From: ILuke [REDACTED]
Sent: 08 November 2016 08:09
To: Muthoora, Leela
Cc: Planning
Subject: 42 Fairfax Road London NW6 REF : 2016/5232/P - RC 08/11/16 logged

42 FAIRFAX ROAD LONDON NW6 REF. 2016/5232/P

*** Photograph to show the 1.5 metre rear abutment of 42 Fairfax Road beyond 44 Fairfax Road as originally constructed.

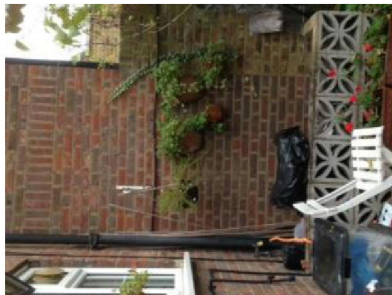
We note inaccuracies in the drawings which have been submitted. The plan drawings show the rear wall of our house set back approximately 800mm

behind that of No. 42. In fact it is actually set back 1.5 metres. Please see photo **attachment**.

*** A reconstructed drawing which, depicted in red and to scale, shows the correction to the actual drawing in the submission, demonstrating that the abutment is 1500 mm, not 800 mm as represented.

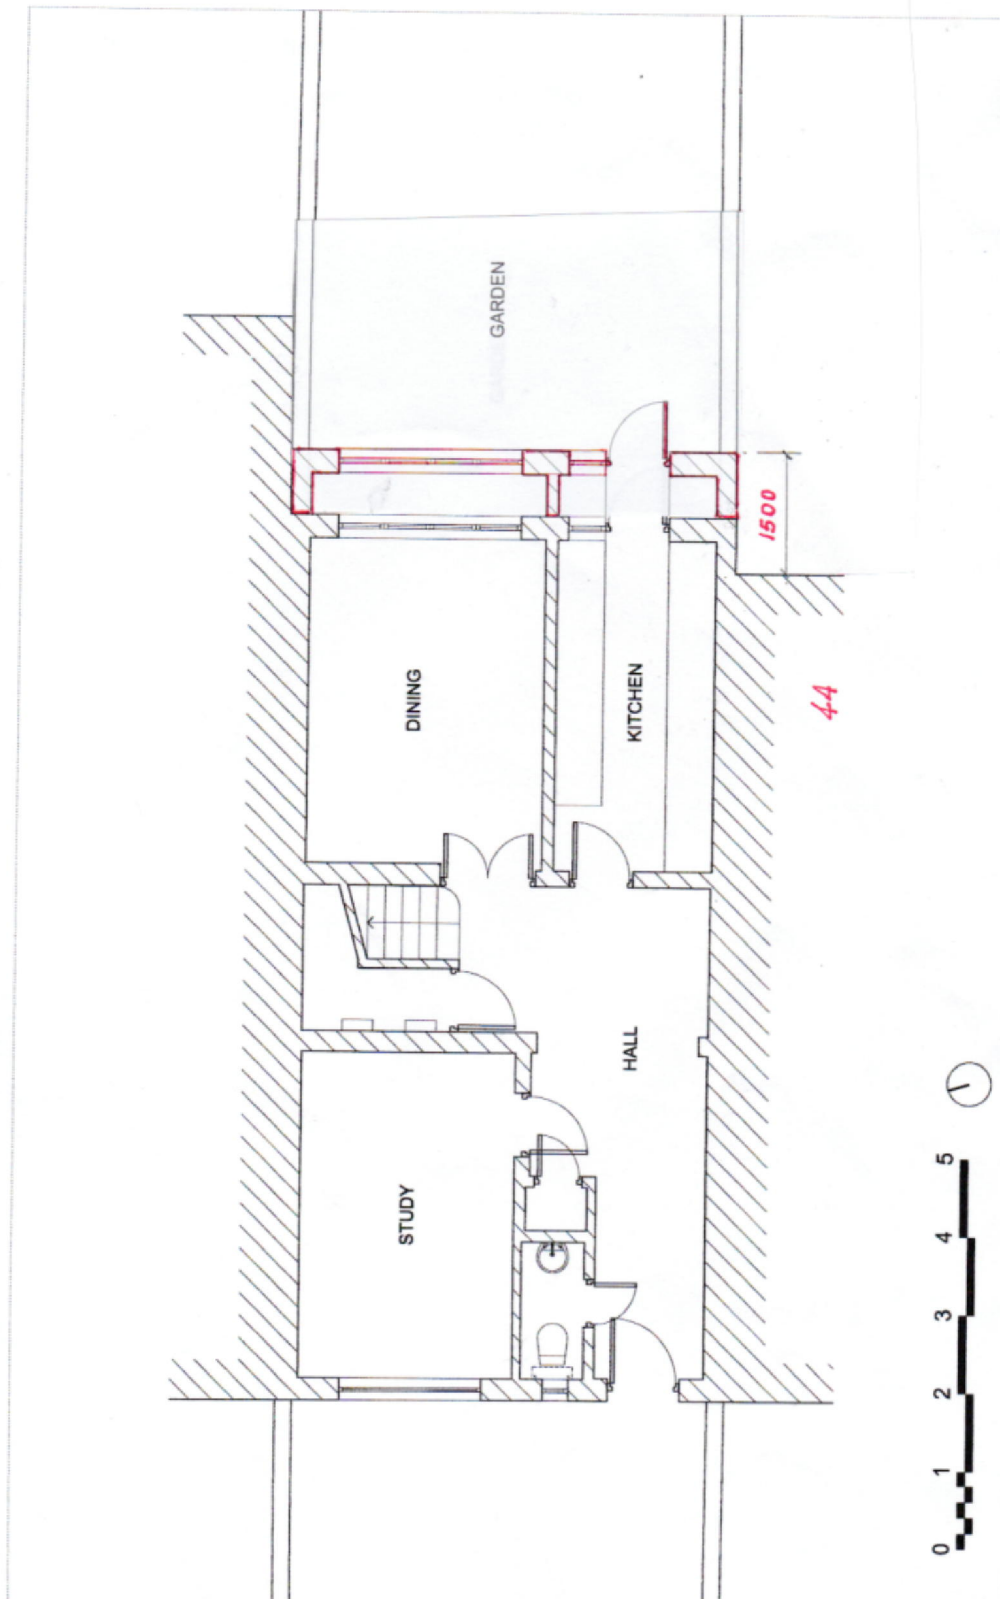
The drawings do not therefore properly show the extent of projection of the proposed extension beyond the rear wall of our house ; the drawings show this as 4.5 metres whereas it is in fact approximately 5.5 metres. The elevation drawings have also not properly represented the difference in level between the ground floor level on our side of the boundary and the extension which, based on the 3 metre dimension provided for the top of the roof of the extension will be more that 3.5 metres high from our side.

We are **attaching** a drawing to demonstrate this error which minimises the actual depth of the 1.5 metre abutment of 42 Fairfax Road beyond our property.
